Our Ref: 18AWE02.4:NvD/LH/MSR
DoP ref: SSD 9741
NSW RFS ref: D18/8341

6 September 2019

**Re: Lane Cove Data Centre – summary of changes for resubmission
Addendum Bushfire Protection Assessment, Vegetation Management Plan,
Watercourse Assessment Report
1 Sirius Road, Lane Cove West**

Figure 1 – Access design (July scheme)

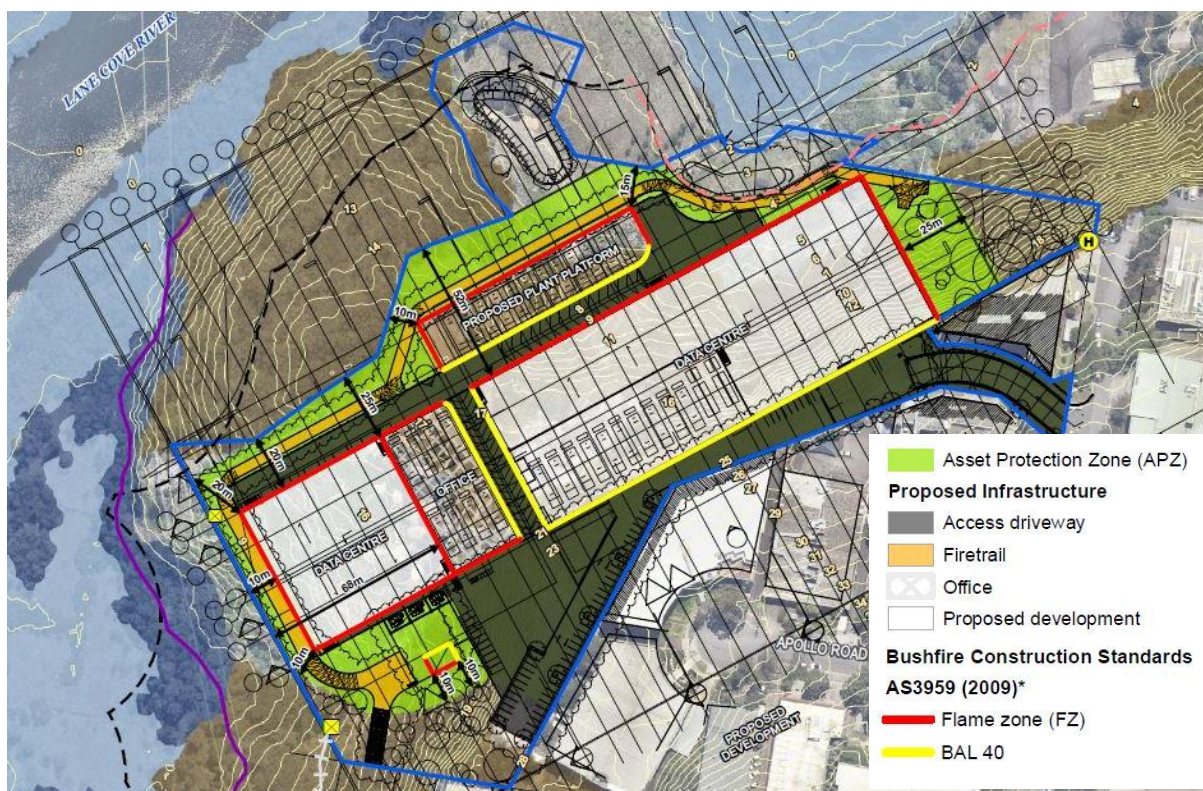
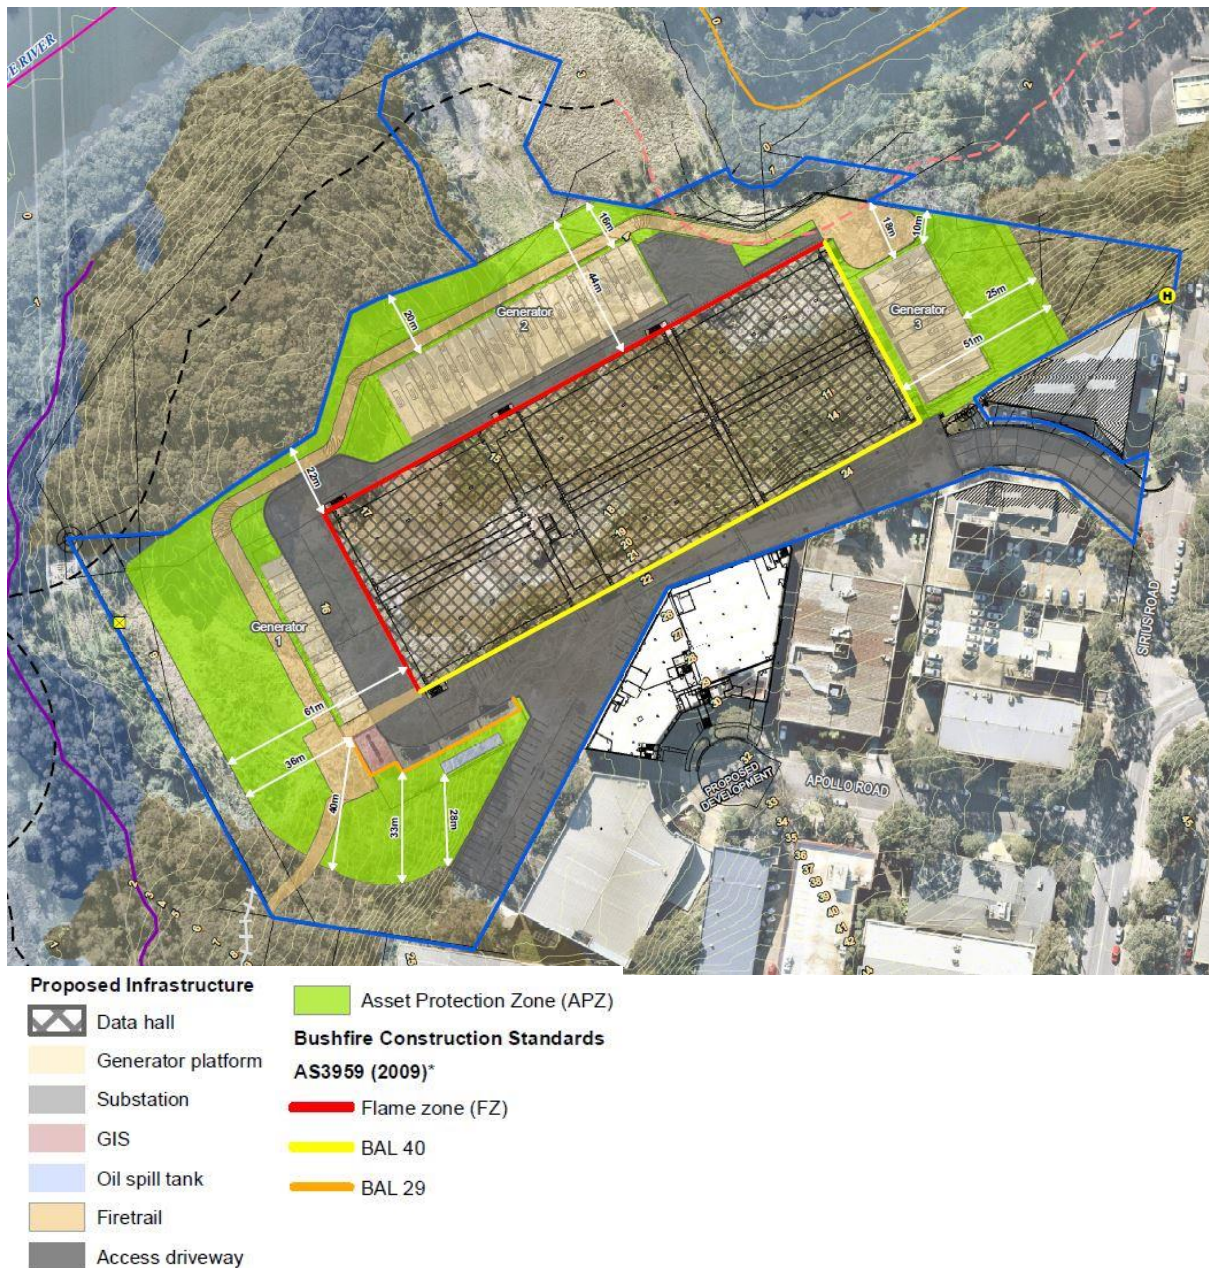
Changes to the driveway include the provision of property access road around the southern, western and northern perimeter of the data centre building. The previous design depicted an access road through the centre of the site between the office and the data centre (refer Figure 1 – access in grey)

The changes to the fire trail design are outlined in Figure 1 & 2 above. The general alignment of the fire trail in the north remains the same. The fire trail in the west now runs adjacent to the generator platform and not adjacent to the western boundary therefore allowing for the retention / regeneration of trees within the western site boundary.

Changes in terms of building construction standards are highlighted in Figures 1 & 2. Based on the amended simplified design the roof, northern and western building facades of the data centre are to comply with BAL FZ. The remaining facades can step down to BAL 40. This is consistent with the recommendations from the NSW RFS.

As outlined in the addendum bushfire report the revised scheme maintains compliance with the NSW RFS conditions for private roads. The revised scheme provides additional firefighting access and increased defendable space around the perimeter of the building therefore improving the bushfire protection measures afforded to the development.
